Type HO.RE.CA.	Model KORO PRIME – KORINTO PRIME	N° T.I. 06 - 2019
Serial Number 91011464	Subject CHANGE MATERIAL OF LIQUID GROUND BASIN	ISSUED FOR (X) Action Information X

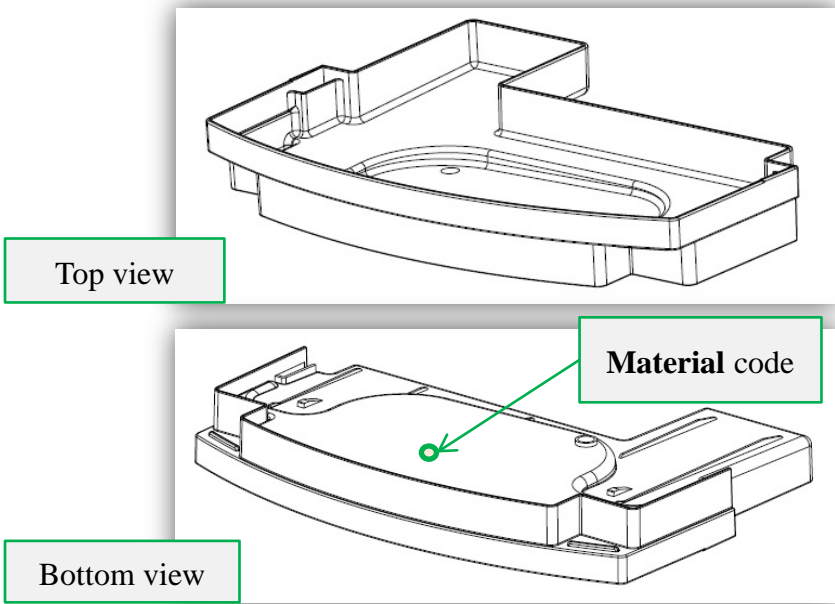
To avoid any possible crack or damage of liquid ground basin, due to contact with acid solutions

The *liquid ground basin* **material** has been modified.

Modified liquid ground basin shiny
Material: **PETG**

Pre – modification liquid ground basin shiny
Material: **PC + ABS**

For machines previous to above **S/N** it's possible to use the **modified liquid ground basin**
